2 Type of change

Product Change Notification					PCN FMW-41 and FMLB case 41 redesign		
owner	creation date	release date	released by	change order no	rev	page	D10-041-450
doriaan	04.12.2019	04.12.2019	romanogu	2018651	A	1 of 2

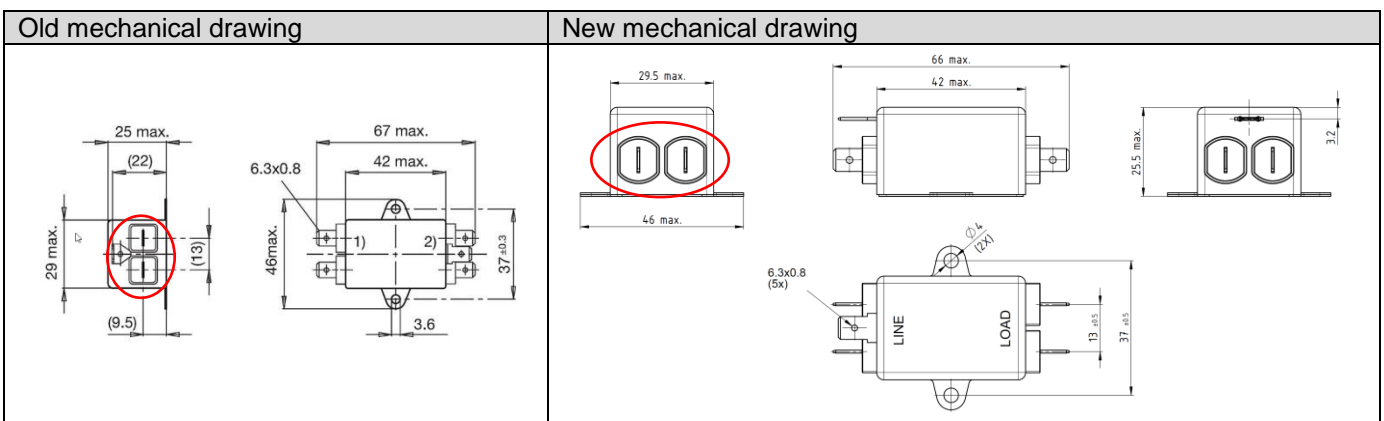
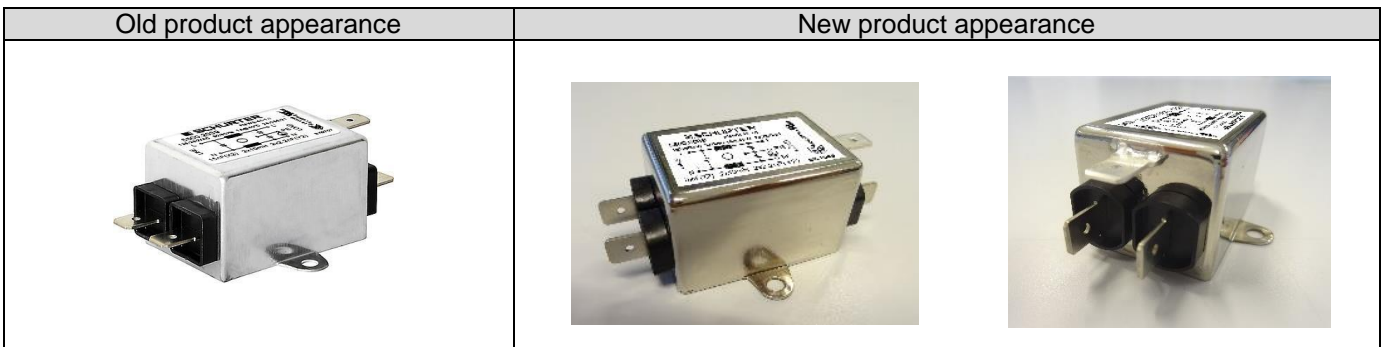
- Nickel plated steel case instead of aluminium case
- Different orientation of external quick connect terminals
- Change of production site

- Change of product appearance due to new nickel plated steel case instead of aluminium case
- Different shape and orientation of plastic part for external quick connector terminals
- New cases are provided with a bottom cover
- Change of factory code from SK to SC and origin from SK to CN on product and packaging labels
